MONTGOMERY COUNTY HISTORIC PRESERVATION COMMISSION
STAFF REPORT

Address:	9403 Warren St., Silver Spring	Meeting Date:	1/8/2025
Resource:	Contributing Resource Linden Lane Historic District	Report Date:	12/31/2024
Applicant:	Cynthia Milloy	Public Notice:	12/25/2024
Review:	Historic Area Work Permit	Tax Credit:	Partial
Permit Number:	1092049	Staff:	Dan Bruechert
PROPOSAL:	Partial demolition and construction of a new addition, and fenestration alterations.

Proposed Elevation

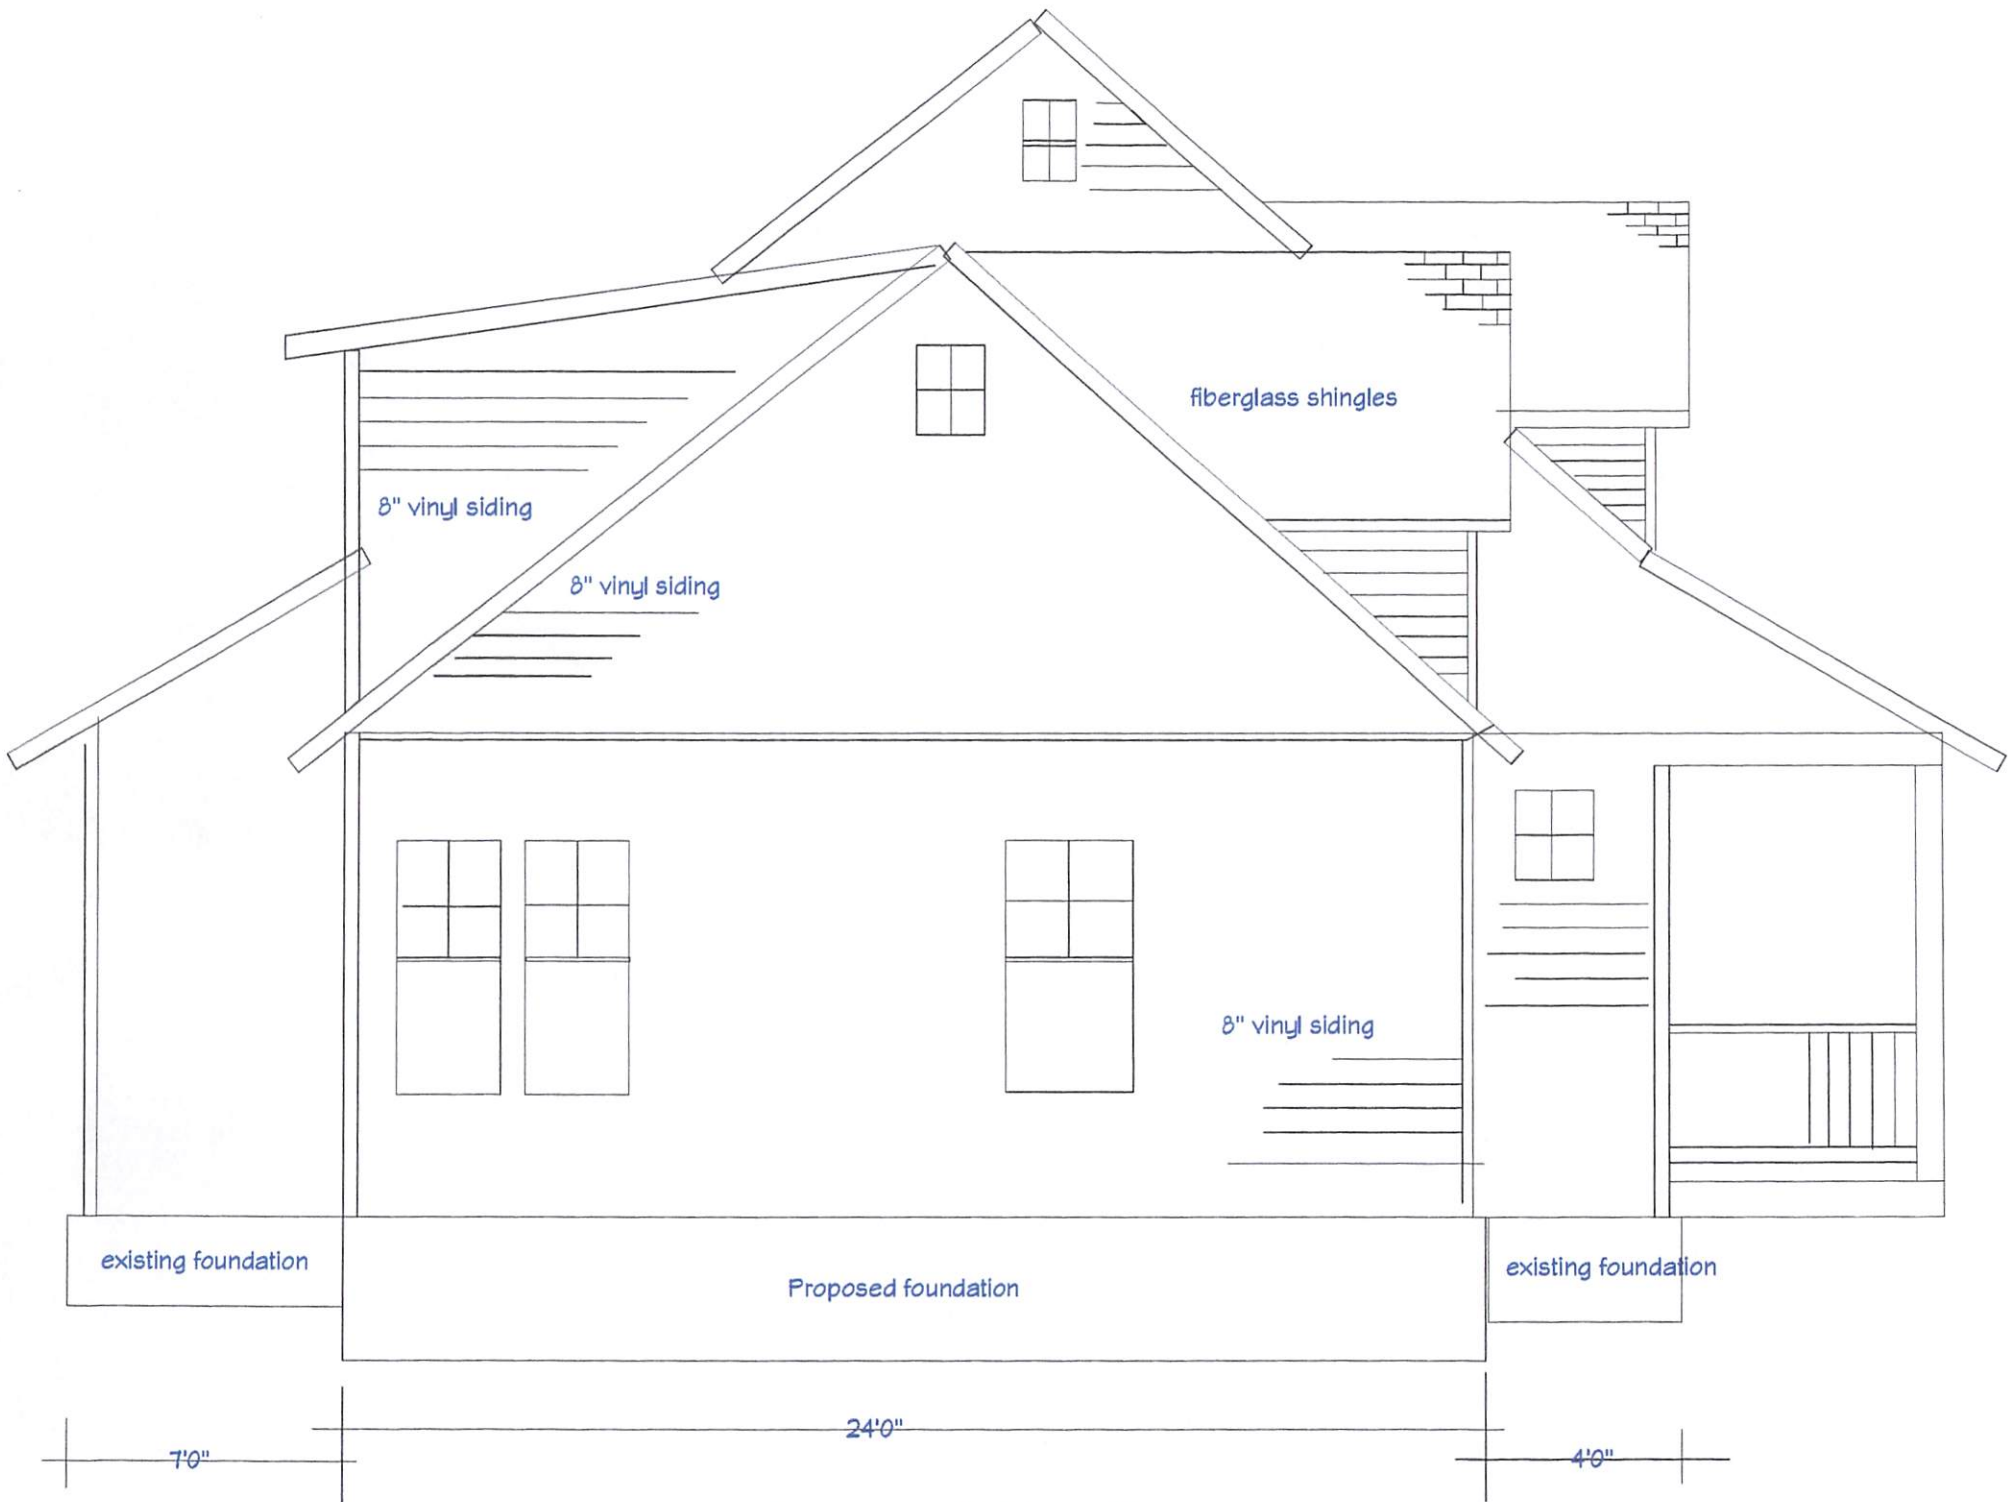
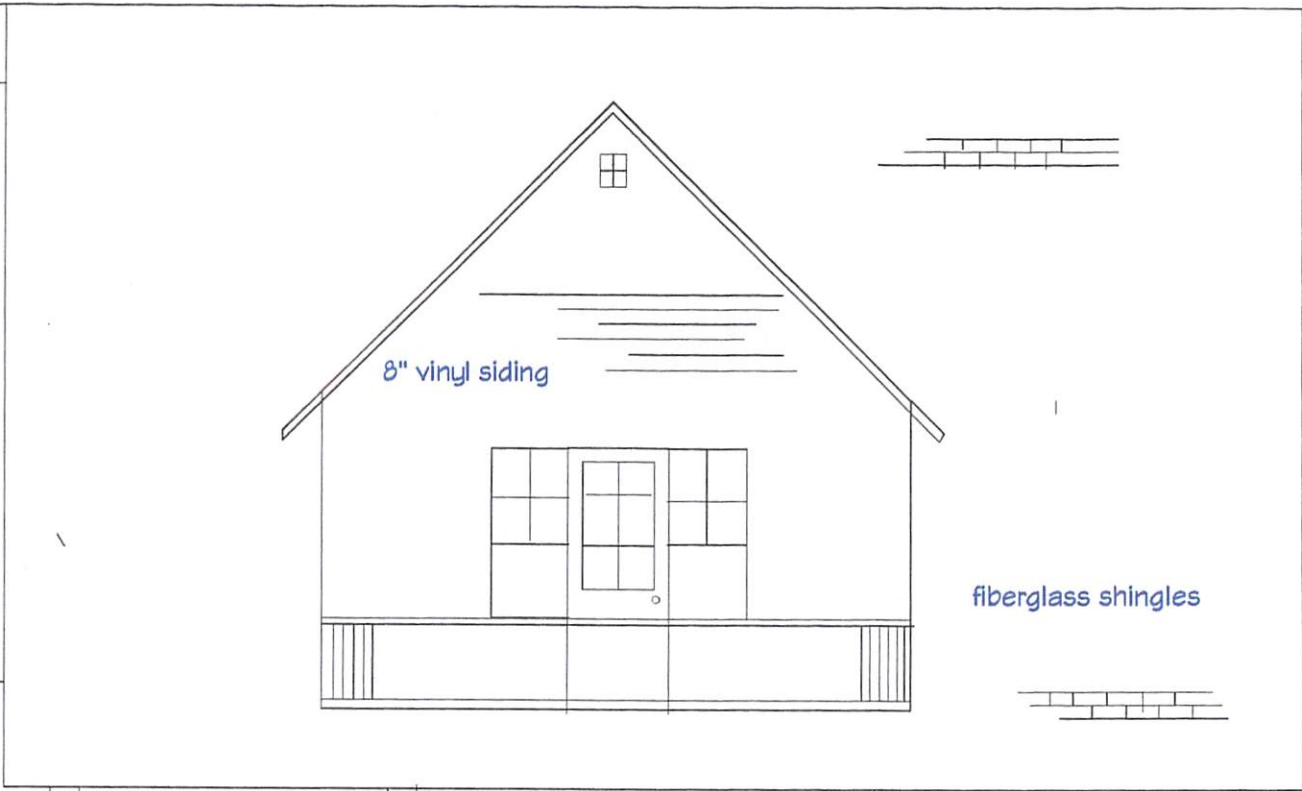
The recommendation for denial centers on the placement of the proposed addition, which is entirely out of character for the District and the historic resource. The typical requirement for additions to houses in historic districts is that they be placed to the rear of the house to limit their visibility and to ensure that the historic house retains its primacy. These requirements ensure compatibility with *Standards 9* and *10*. Or as stated in the National Park Service's *Interpreting the Standards Bulletin #37*, "whenever possible, new additions should be constructed on the rear elevations where they will have less of an impact on the building's historic integrity."³ There have been times where the HPC has permitted rear additions to extend more to the side so that the rear addition would be viewable from the street; however, in these cases, the addition itself is still placed to the rear of the historic house so the clear hierarchy of the historic to new construction is maintained.

Figure 2: Perspective view of the proposed left-side addition (note: the window placement is for illustrative purposes only).

Staff finds constructing an addition to the side of the house will negatively impact the appearance of the house and its massing as viewed from the house front and is incompatible with the house's simple bungalow form. When evaluating building additions, one of the primary considerations is how does the addition impact the historic house form? The subject house is a very typical side-gable Craftsman Bungalow, with a nearly square footprint, full-width front porch, and prominent dormer. While the ground floor fenestration is not symmetrical, the entire mass of the historic building has a balanced form. By adding an addition to the left side of the house, that balance is eliminated, and the massing is altered in an incompatible manner contravening *Standard 9*.

Recognizing that this is a corner lot, more of the addition will be visible from the public right-of-way regardless of where it is constructed. However, that does not mean that it is appropriate to install an addition anywhere on the building. The analysis of the proposal requires a measured approach that evaluates the location that best preserves the historic character and historic materials. Obviously, constructing an addition off of the front elevation would destroy the house's historic form and all architectural details and it would not be appropriate to install an addition to that elevation. Staff finds installing an addition off of the right addition would negatively impact the relationship between the historic house and Linden Lane and the larger spacing between the houses in this historic district. An addition to the rear that was inset of the side wall planes would preserve the outline and form of the historic house. While Staff finds an addition in this location would be just as visible from the public right-of-way as the proposed addition, it would more successfully preserve the massing and form of the historic building as required by *Standard 9*. Because the rear addition is less significant from considerations of architectural hierarchy, Staff finds more extensive changes should be allowed on this elevation under 24A-8(b)(2) and (d) and *Standard 2*.

Based on the inappropriate location, Staff recommends the HPC deny the proposed addition under 24A-8(a) for contravening 24A-8(b)(1) and (2); and *Standards 2* and *9*.
